**Report: TAB Report**  
**Function: Test, Adjust, & Balance**  
**Date: 08/20/2025**  
**Completed By: National TAB**

## 08-18-25 WHATABURGER #1449 TUCSON, AZ

Project: 08-18-25 WHATABURGER #1449 TUCSON, AZ

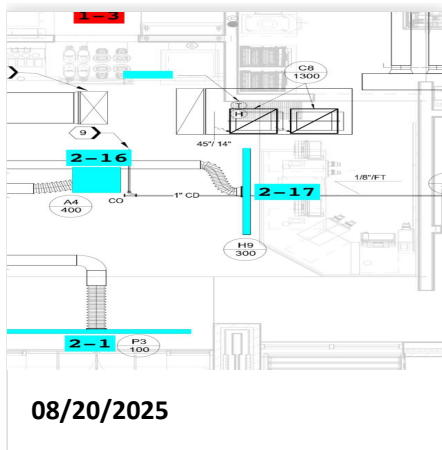
**Issue Name :** COMPRESSORS NOT OPERATIONAL  
**Description :** Unit running but not cooling. Tried jumping units into cooling but it would not run. The unit needs to be serviced.  
**Created By :** National TAB                      **Assigned To :** National TAB - Dan Hertenstein  
**Status :** Open  
**Priority :** [Medium](#)                      **Asset Tag :** RTU1  
**Originated Date :** 08/20/2025 - Christine Weale - National TAB

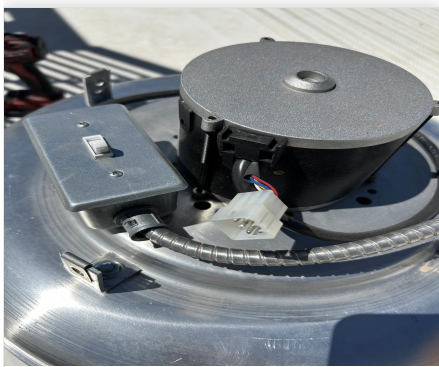
**Issue Name :** DIRTY FINAL FILTERS  
**Description :** RTU-1 and RTU-2 final filters are dirty. Recommend replacement.  
**Created By :** National TAB                      **Assigned To :** National TAB - Dan Hertenstein  
**Status :** Open  
**Priority :** Low                                      **Asset Tag :** RTU1  
**Originated Date :** 08/20/2025 - Christine Weale - National TAB
